Re: Planning Proposal - 300 Manchester Road, Auburn (PP-1/2018)

Subject 300 Manchester Road, Auburn – Planning Proposal Response

**Preliminary Exhibition of a Planning Proposal Request for 300 Manchester Road, Auburn
(Lots 11 and 12 DP1166540)**

**Preliminary Exhibition of a Planning Proposal, 300 Manchester Road, Auburn
(Lots 11 & 12 DP 1166540) PP-1/2018**

PA016056 - Manchester Road, Auburn Planning Proposal_Revision C

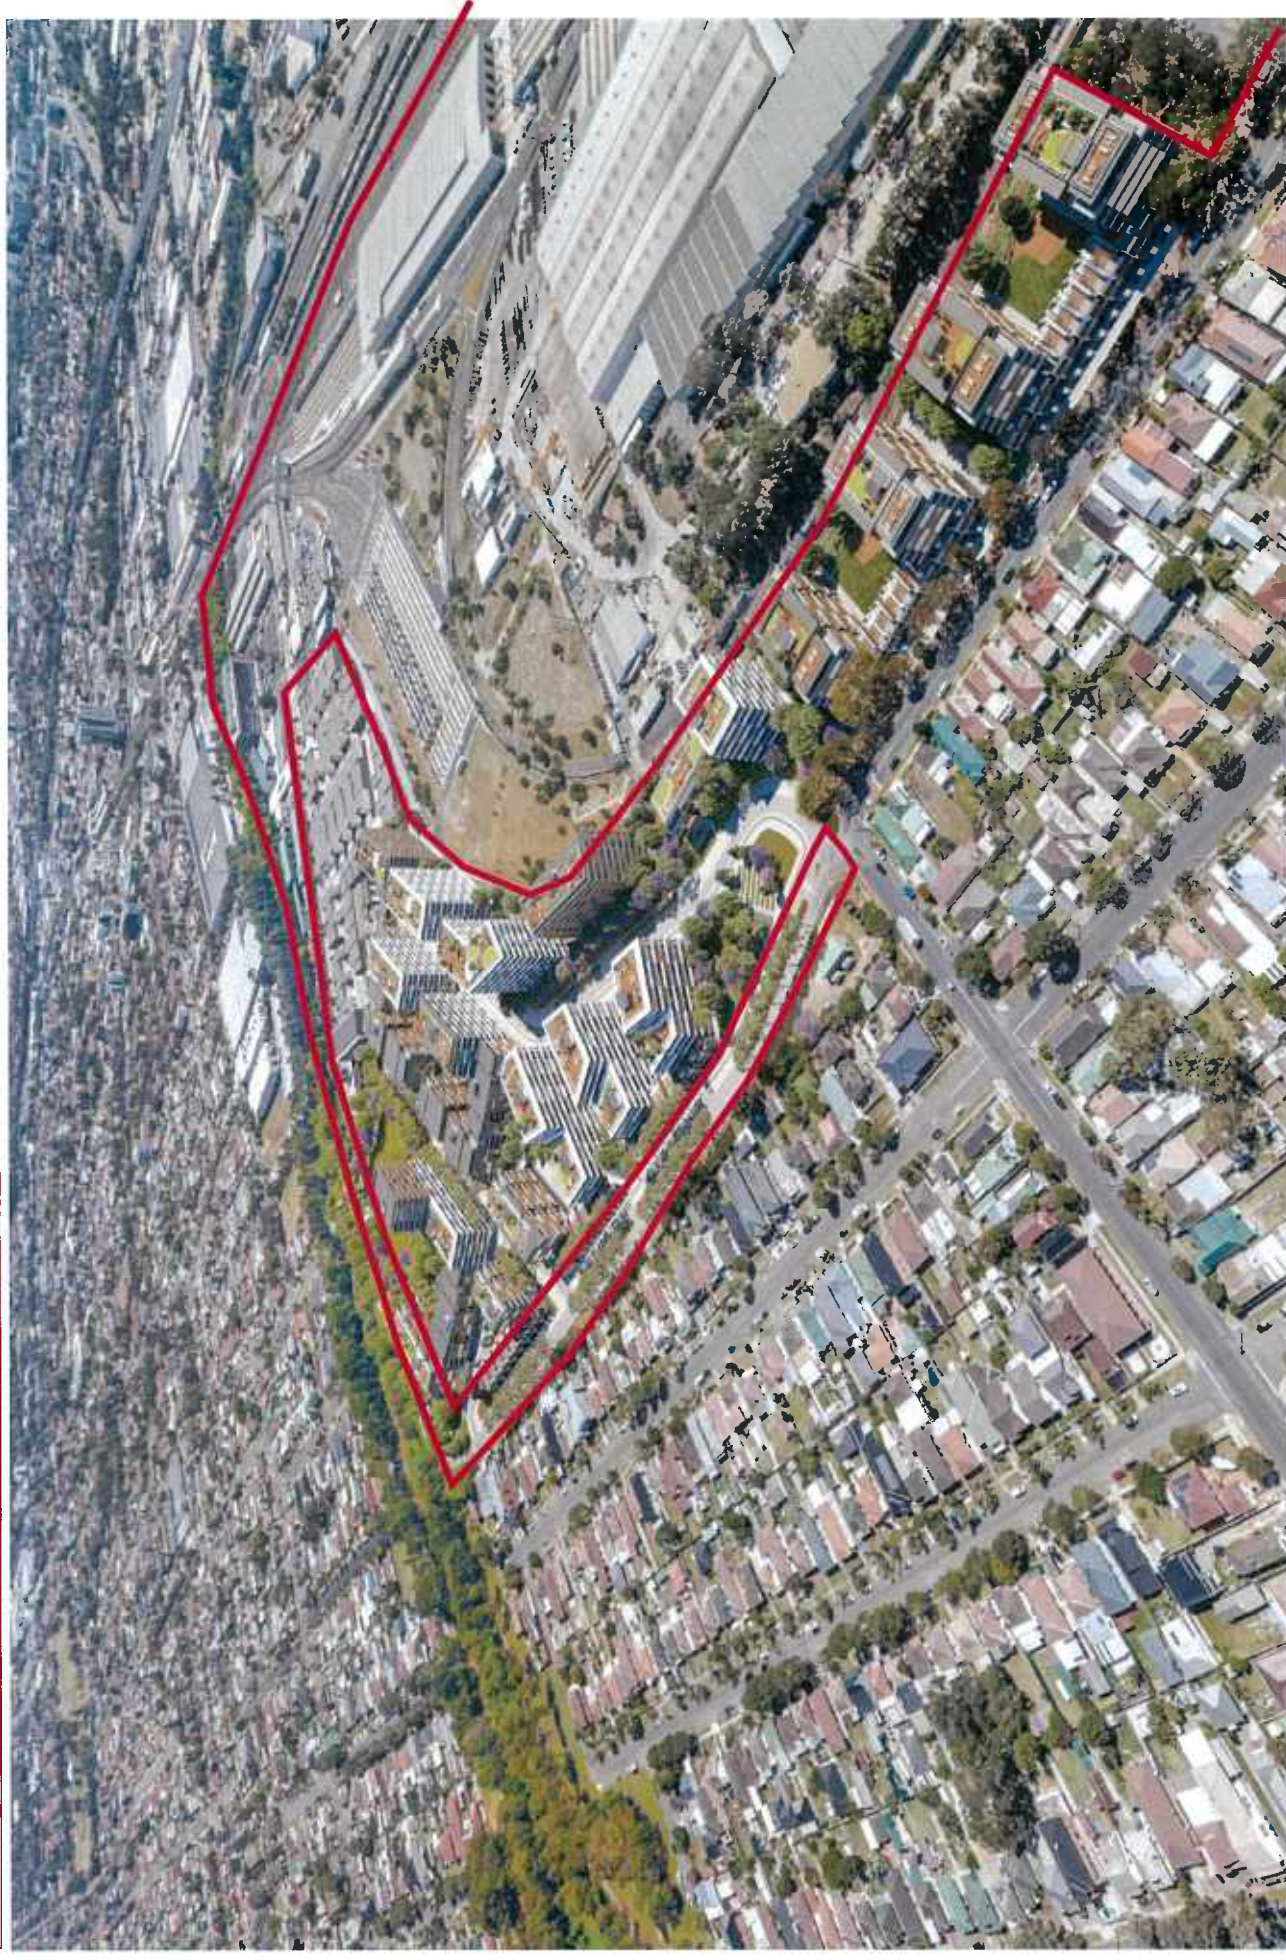
The RailCorp/Sydney Sydney Trains land affected is shown in blue outline.

The Payce site currently acts as a buffer between the Clyde Yard and existing residential areas

The Payce proposal now introduces an incompatible use (residential) directly abutting the Clyde Yard.

The Payce site proposes to introduce residential development directly abutting the rail yard. This residential use is considered to be incompatible with the adjoining rail use and goes against sound planning principles. The site is better suited for employment uses.

The RailCorp/Sydney Trains site is shown in blue outline. Payce proposes to site the tallest buildings closest to the Yard. The current noise wall along the property boundary will not provide any noise attenuation to dwellings located above the height of the noise wall. It can also be seen that Payce proposes works and to introduce public access on land owned by RailCorp that Payce has no legal right to offer, including the provision of the bridge over Duck River. The only rights that Payce has is the right of way as shown in magenta outline.

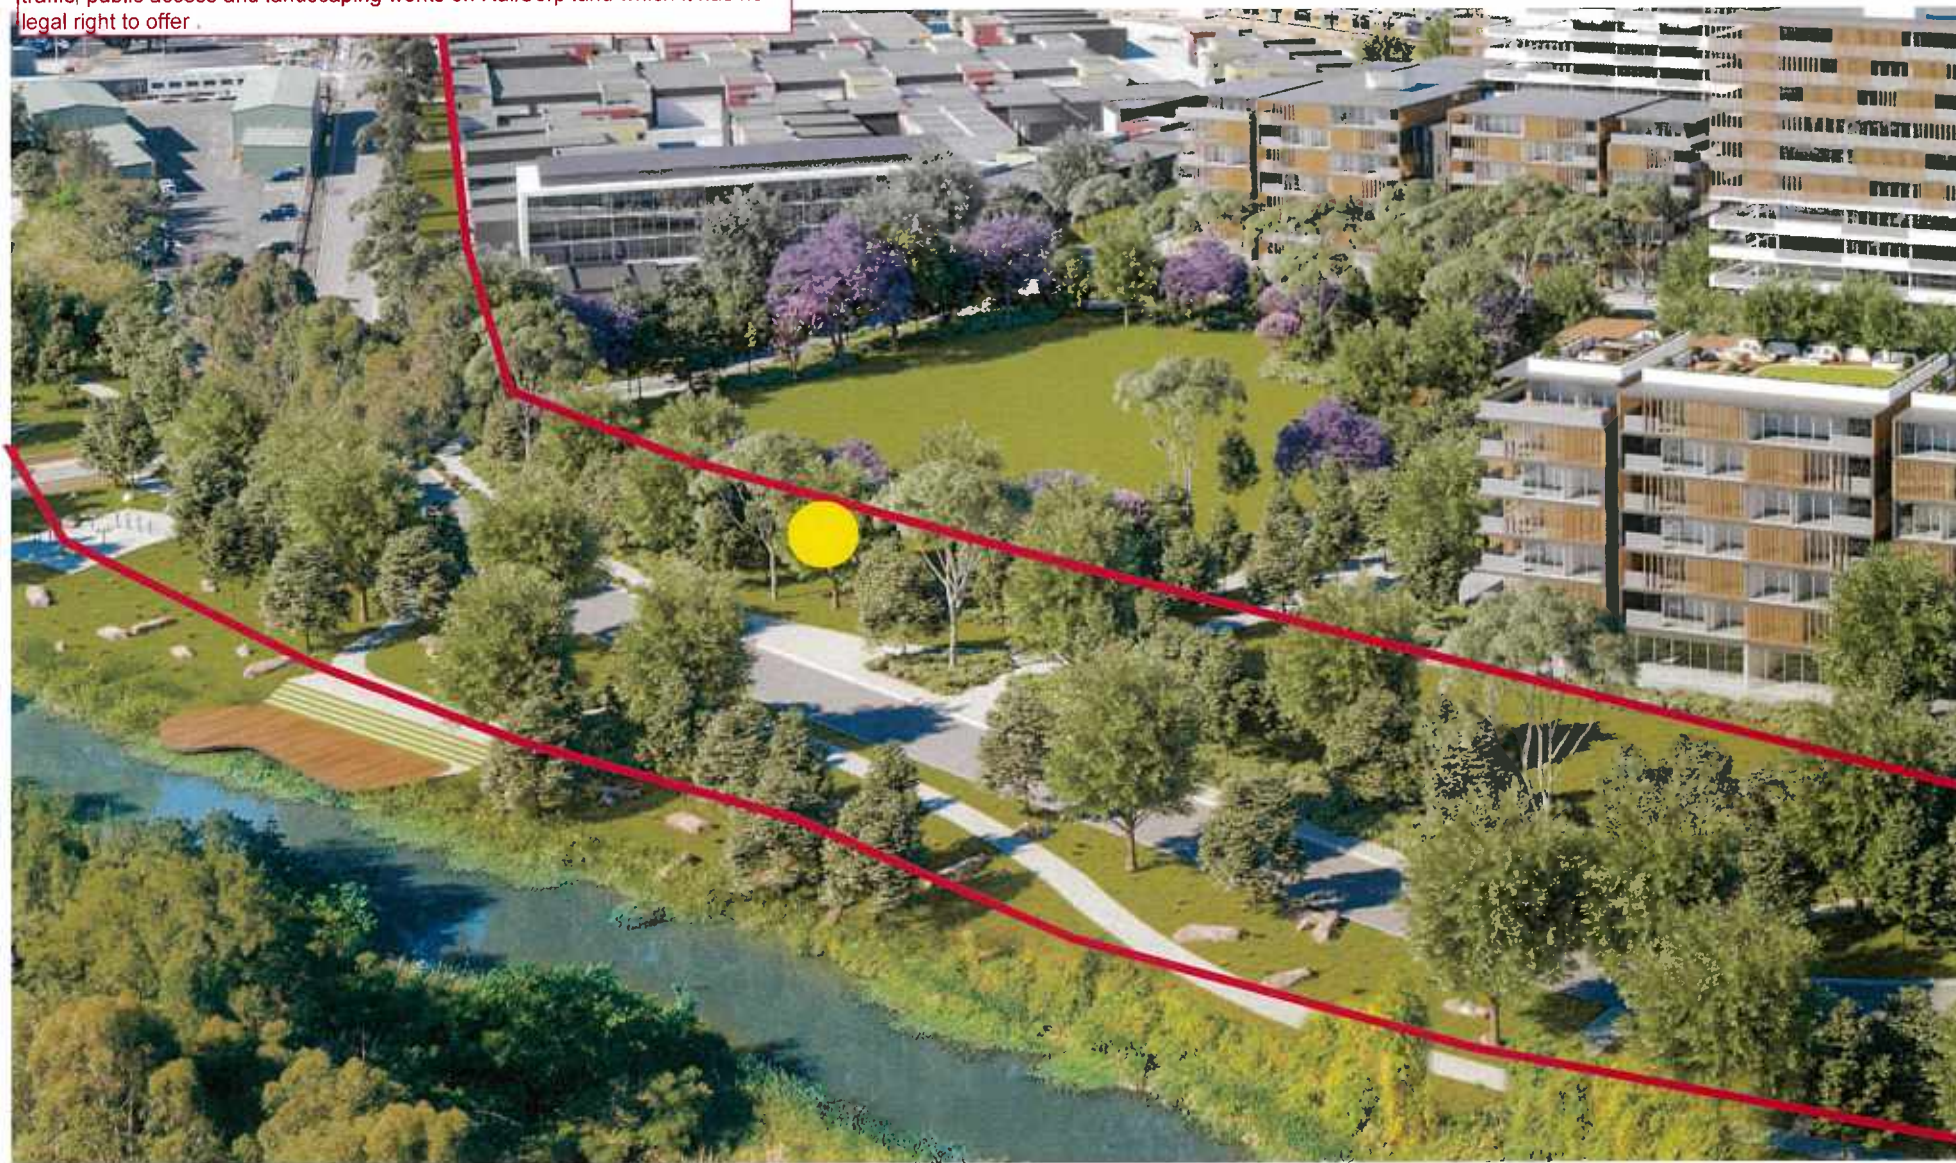
The area between the two red lines is RailCorp land that forms part of the private Manchester Rd. This private road only provides access to the Clyde Yard and to the Payce site via a right of way single point connection at the location shown with yellow circle. Payce proposes to introduce additional traffic, public access and landscaping works on RailCorp land which it has no legal right to offer.

Payce proposes to construct a bridge over Duck River that it cannot physically connect to their land given the presence of RailCorp land between the Payce site and the river. Payce has no legal rights to offer this bridge under their planning proposal
